AERONAUTICAL CHARTING FORUM
Instrument Procedures Group
October 23, 2012

FAA Control # 12-02-302

Subject: Multiple Climb Gradients on Standard Instrument Departure (SID) Charts.

JEPPESEN SALT LAKE CITY, UTAH
14 NOV 08 (10-3B) Eff 20 Nov RNAV SID

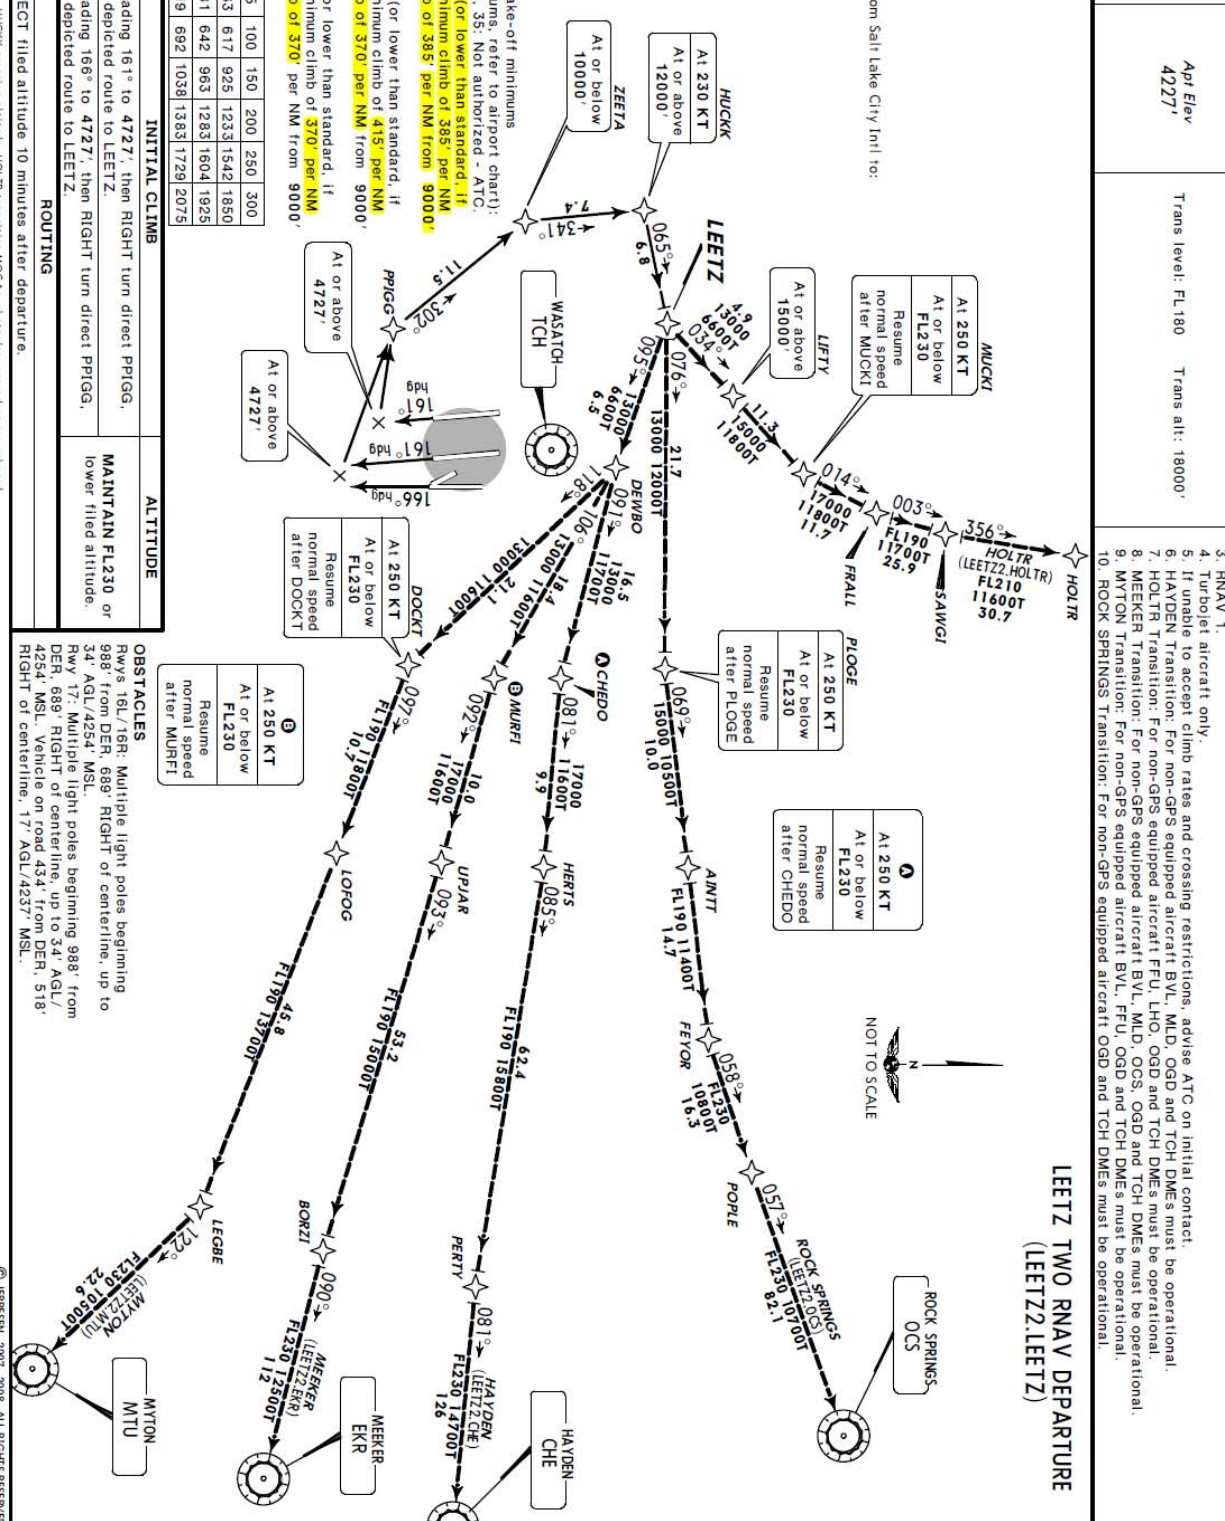
Background/Discussion: Multiple climb gradients are currently being depicted on some SID charts; one for obstacle clearance and one for ATC altitude restrictions. This practice has recently started at Salt Lake City (SLC) - see the attached LEETZ 2 RNAV Departure. Previously, only the min climb gradient was annotated on this chart and having multiple CG's clutters up the chart unnecessarily. FAA order 8260.3, *US Standard for terminal Instrument Procedures (TERPS)*, allows only one climb gradient for obstacle clearance purposes. However, FAA Order 8260.46, *Departure Procedure (DP) Program*, allows multiple climb gradients when necessary for ATC purposes.

Multiple climb gradients, especially when duplicated, contribute to unnecessary chart clutter.

Recommendations: Revise policy to specify that only the highest required climb gradient for any given segment of a SID be specified on the procedure.

Initial Discussion - MEETING 12-02: New recommendation presented by Kevin Allen, US Airways. Kevin expressed concern that there are SIDs that have multiple climb gradients published; one for obstacle clearance and one (or more) for ATC altitude restrictions. This appears to be a contradiction between two FAA 8260-series Orders. Order 8260.3, *US Standard for Terminal Instrument Procedures (TERPS)* allows only one climb gradient for obstacle clearance purposes. However, FAA Order 8260.46, *Departure Procedure (DP) Program*, allows multiple climb gradients when necessary for ATC purposes. These multiple climb gradients, especially when duplicated, contribute to unnecessary chart clutter. US Airways recommends the FAA revise policy to specify that only the highest required climb gradient for any given segment of a SID be specified for the departure procedure. Kevin also recommended that charting could use a slash (/) vice "per" when specifying the climb gradient; e.g., "360'/NM" vice "360' per NM". Bill Hammett, AFS-420 (ISI) responded that there are restrictions on the use of symbols allowed in international NOTAMs; however, he was unsure if the slash is restricted. Tom Loney, Canadian Air Force, mentioned that not all aircraft have the same climb performance capabilities; therefore, pilots of less capable aircraft should have all the relevant information available. Tom Schneider, AFS-420, stated that criteria drives policy. The new Order 8260.58, which was effective September 12, 2012 and replaced Orders 8260.44, 8260.45, 8260.52, and 8260.54, as the standard for RNAV procedures, removed the provision that allowed multiple climb gradients. As noted above, Order 8260.3 also allows only one climb gradient; therefore, all reference to multiple climb gradients has been removed in the upcoming guidance in Change 3 to Order 8260.46. The premise is "one altitude at a fix will define one climb gradient". The scenario used in the example given by US Airways will be eliminated in the future. Chris Jones, AFS-410 (Support), stated that this scenario could cause an adverse impact in that some operators who cannot meet the specified climb gradient may not be able to use the procedure. Tom Schneider, AFS-420, responded that this has been discussed at several FAA/industry ad hoc departure meetings/telcons and the consensus was that this is acceptable. The group consensus is that the issue may be closed based on Order 8260.58 and the upcoming Change 3 to Order 8260.46. **ITEM CLOSED**
